AMENDMENTS TO THE DRAWINGS

10/790,932

REMARKS

Drawing and Specification Amendments Address Drawing and Specification Objections

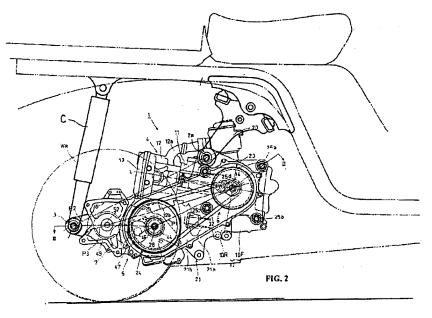
Fukamachi et al. taught an all terrain vehicle, which is significantly different in construction than the truck taught by Leipert. An image that combines the images of Figure 1 and Figure 2 of Fukamachi is shown below. As shown, the engine of Fukamachi was an internal

The engine received an air/fuel mixture through an air intake system. The air intake system featured a carburetor 20 (shown almost directly vertically below a rear portion of the seat) and an

intake port 12a. An intake passage extended between the intake port 12a and the carburetor. The engine of Fukamachi was designed to pivot relative to the frame because it was directly connected to the rear wheels. Thus, the wheels and the engine were connected to the shock absorber C.
